Access Compliance Report

Public Rights-of-Way

(Curb Ramps)

Intersection ID: 27177	Main Street: PROVIDENCE_RD	Cross Street: MCKEE_RD	Location: SW
ADA ID: 0A8BB7D081BD	Ramp Type: Perp	Initial Pass/Fail: Fail	Overall Compliance: No
Severity Score: 21.25			
Codes/Mitigation Info/Possible Solution		Field Measurements/Component Compliance

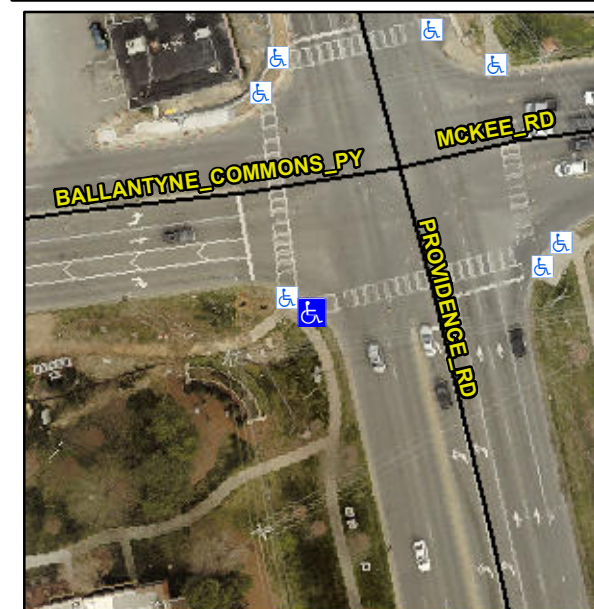
Not Found, R304.5.1, R304.2.2

Compliance	Description	Data	Compliance	Description	Data
N/A	Ramp Length (in)	74.0	No	Ramp Slope (%)	10.1
No	Ramp Width (in)	46.0	Yes	Ramp XSlope (%)	1.4
N/A	Flare Type LT	N/A	N/A	Flare Type RT	N/A
N/A	Flare Slope LT (%)	N/A	N/A	Flare Slope RT (%)	N/A
N/A	Flare Traversable LT?	N/A	N/A	Flare Traversable RT?	N/A
N/A	Landing Length (in)	N/A	N/A	DWS Provided?	N/A
N/A	Landing Width (in)	N/A	N/A	DWS Contrast?	N/A
N/A	Landing Slope (%)	N/A	N/A	DWS Length (in)	N/A
N/A	Landing X Slope (%)	N/A	N/A	DWS Full Width?	N/A
N/A	Landing Curb? (Y/N)	N/A	N/A	DWS Offset (in)	N/A
N/A	Shared Landing?	N/A			
N/A	Gutter Ponding?	N/A	N/A	Gutter Slope (%)	N/A
N/A	Gutter Lip Ht (in)	N/A	N/A	Gutter X Slope (%)	N/A
N/A	Painted X Walk1?	Yes	N/A	Painted X Walk2?	N/A
	X Walk 1 Direction	To E		X Walk 2 Direction	N/A
N/A	X Walk 1 Width (in)	90.0	N/A	X Walk 2 Width (in)	N/A
	X Walk 1 Slope (%)	1.5		X Walk 2 Slope (%)	N/A
	X Walk 1 X Slope (%)	1.3		X Walk 2 X Slope (%)	N/A

Remove & Replace Entire Ramp.
